2025 E12th Avenue and 2776 Semlin Drive

Stephen Bohus, BLA, Grandview-Woodland resident and renter

Rezoning Application - 2776 Semlin Drive and 2025 East 12th Avenue

Maximum 6,500 sq ft floorplate (in this case, for 6th storey), or 603.9m²

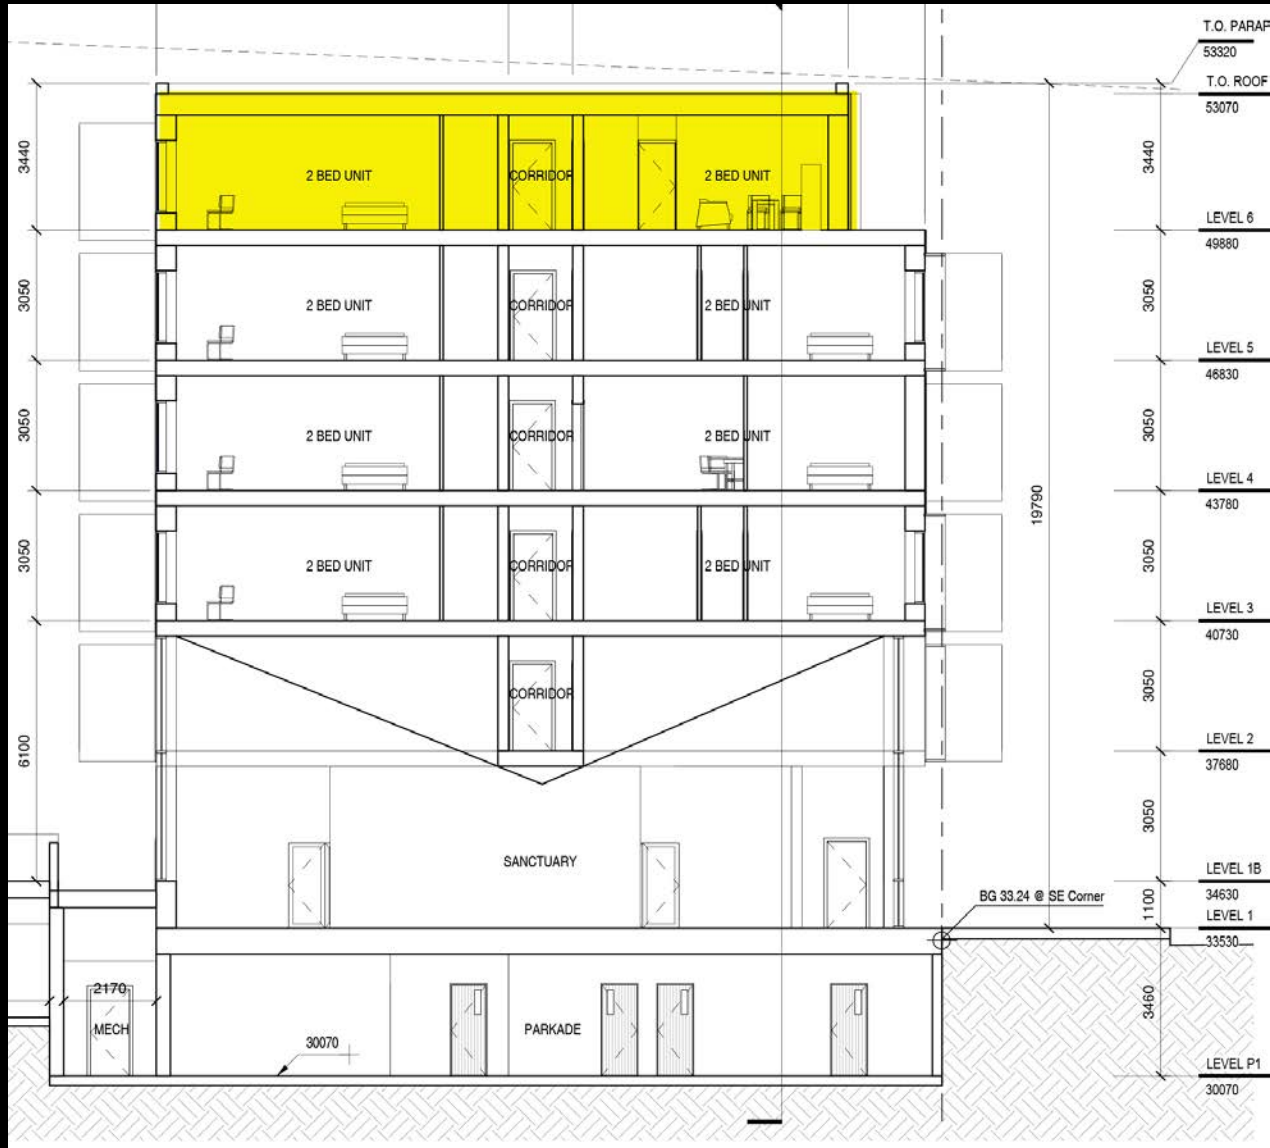
6th Floor Floorplate area is 194% of allowed maximum

Floorplate area is 12,634.5 sq ft vs. 6,500 maximum in policy
(1,173.84m² proposed vs. 603.9m² in policy), 94% over
Note: even larger floorplates on lower floors

Floorplate exceeds maximum in policy

6th Floor Floorplate: between 16.35m and 19.79m in height

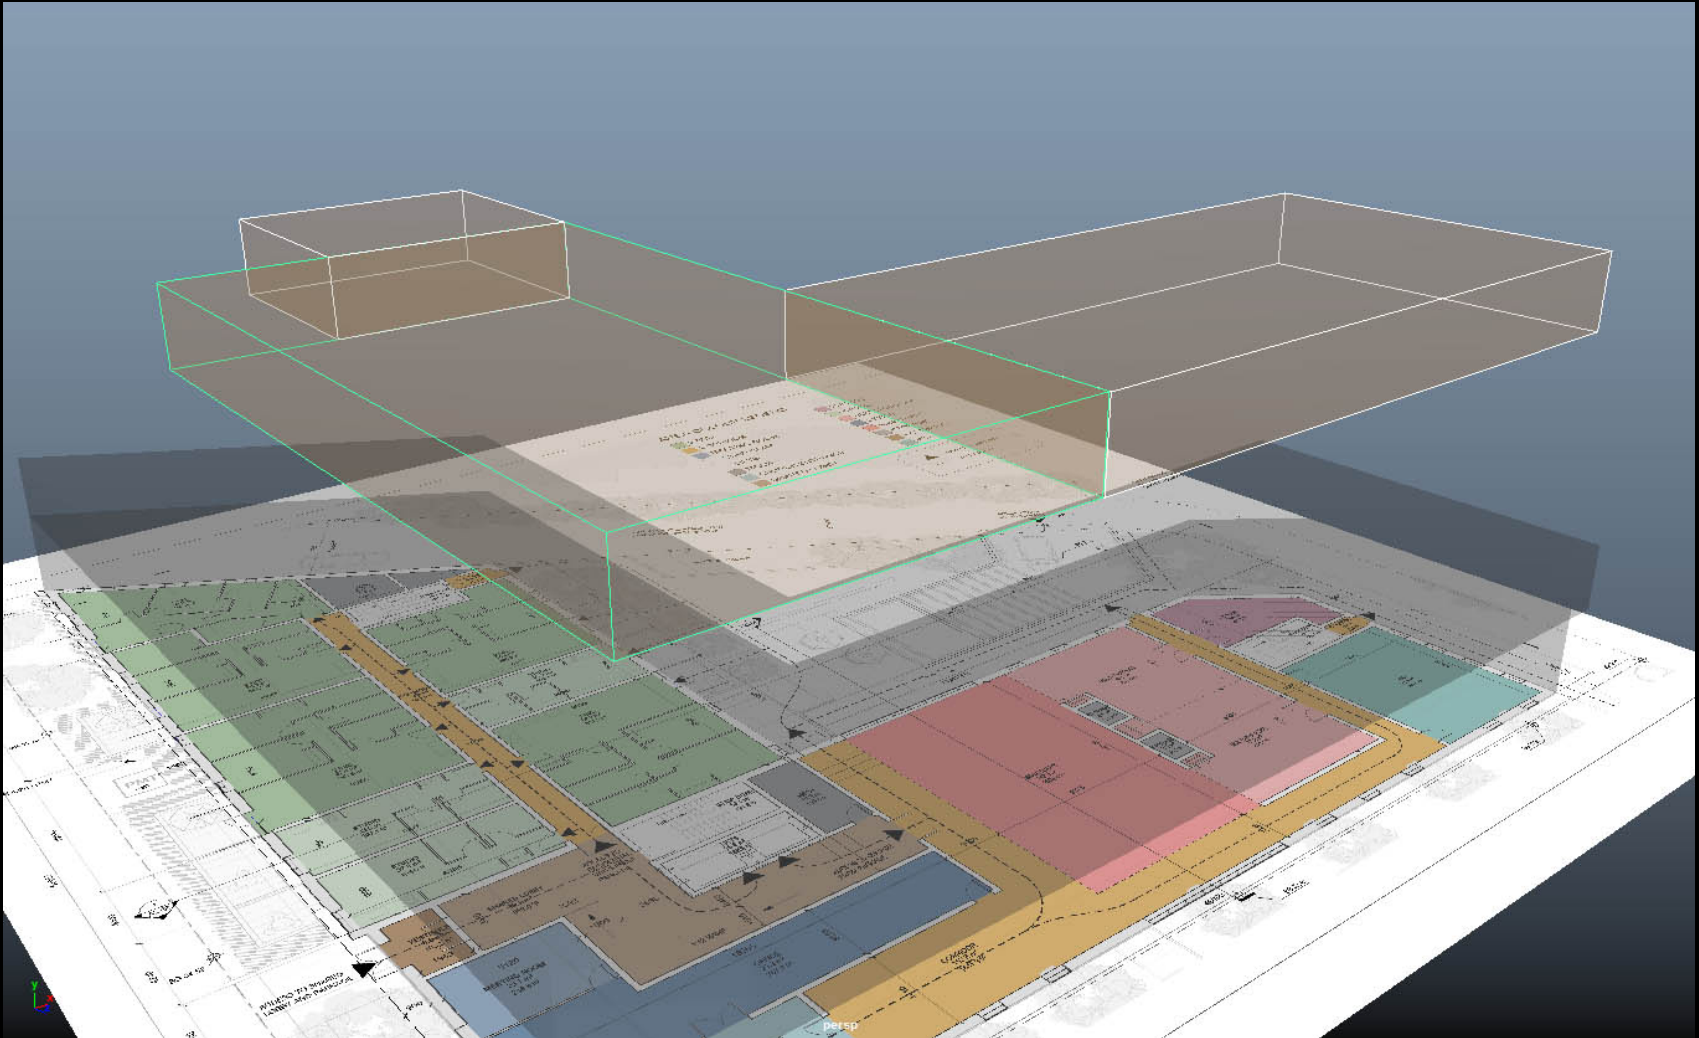
Is this a normal roof? Is there an opportunity for a Green Roof?
Should massing be split up into 2-3 smaller buildings?

Setback Policy: Front 3m (10 ft) / Side 2.1m (7 ft.)

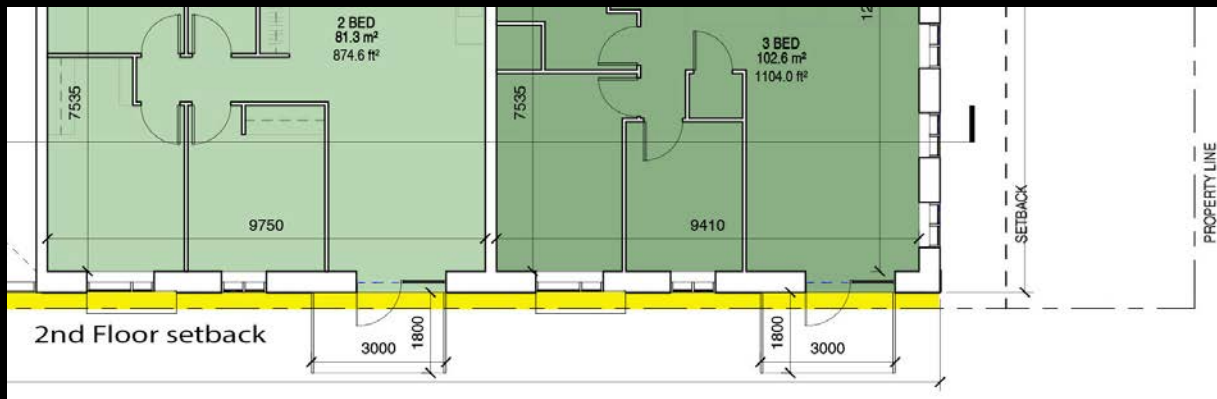
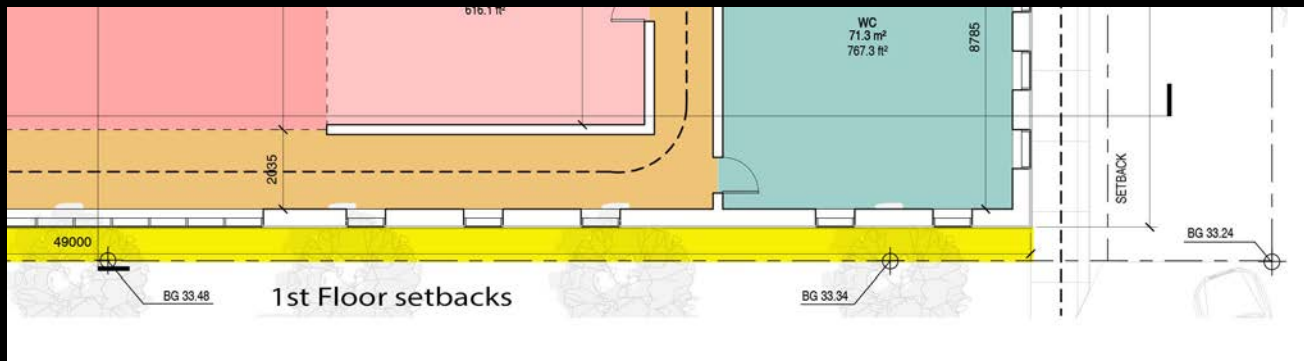
Front **setback ~0.84 metres** (scaled from drawing, ~2.76 ft.)

Does not conform to minimum setback in policy (3m)

Also note balcony setbacks and encroachments

Rendering: no reference, before or after (compare with photo)

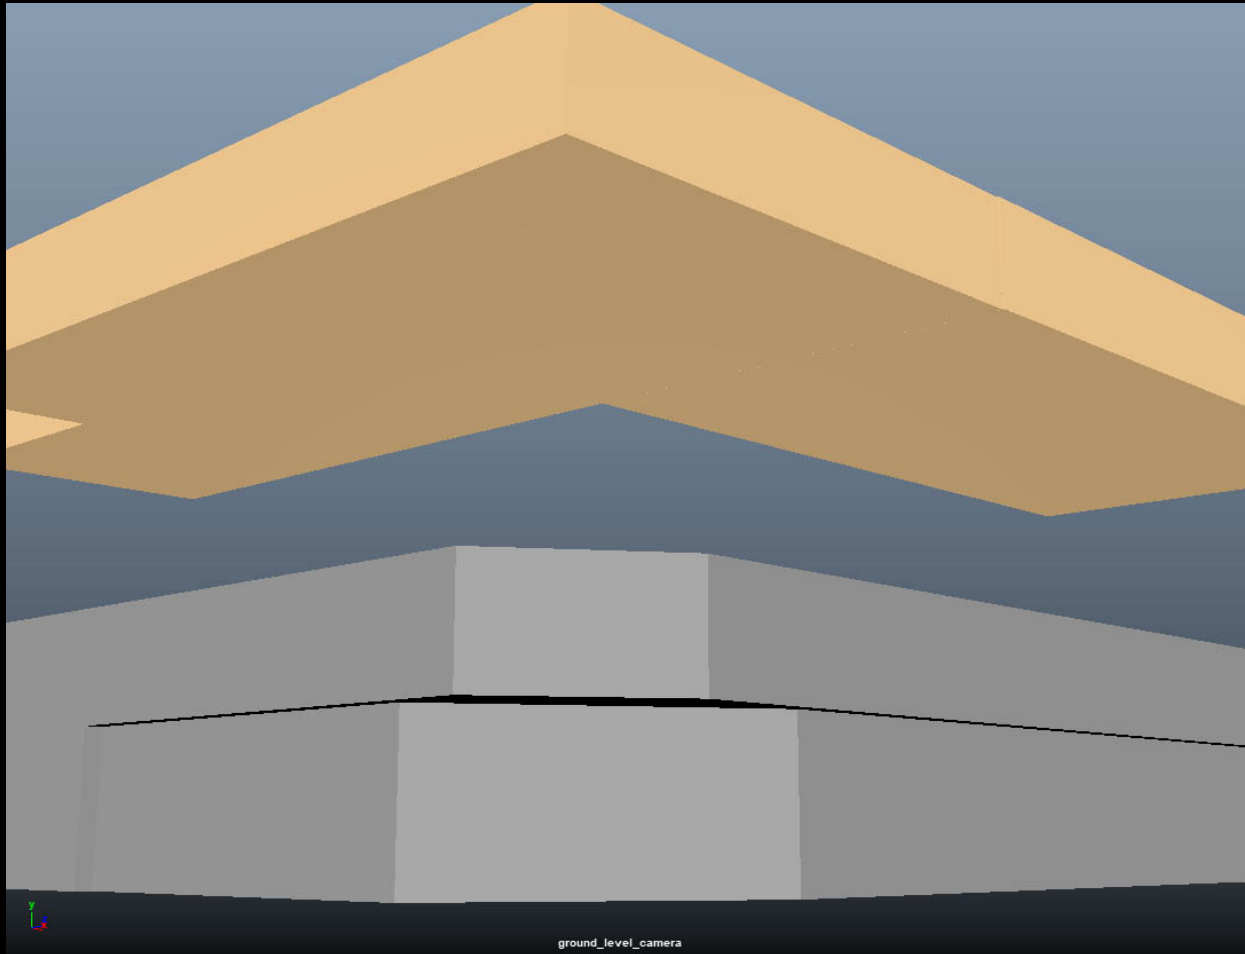
Issues with Rendering: no reference, before or after (compare with photo)

Trees are much smaller in reality

than on the renderings

50mm lens is a standard, no information about rendering
(is rendering equivalent to a very wide angle lens?)
Need to look at human scale and experience from the street
